TECHNICAL SERVICES INFORMATION BULLETIN

TSIB 22-03 Rev A		February 16, 2022
TO:	All Operators	
TITLE:	Kiel Avance Seat Retaining Hardware Replacement	
APPLICABILITY:	MCI coaches equipped with Kiel Avance seat models 1020, 1030, 2010, 2025, and 2050 before MY 2020 (VIN: J4500- 69517, J3500- 21031, D45CRTLE- 81035, D4000/D4500/D4505/D4005/D4000 ISTV- 15537)

Picture 6.

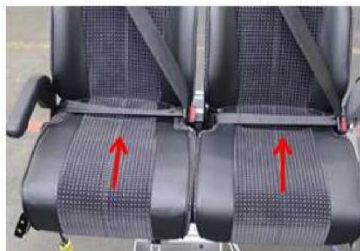
Use 10mm hex tool to hold screw while using 19mm wrench to tighten lock nut (2 per seat place).
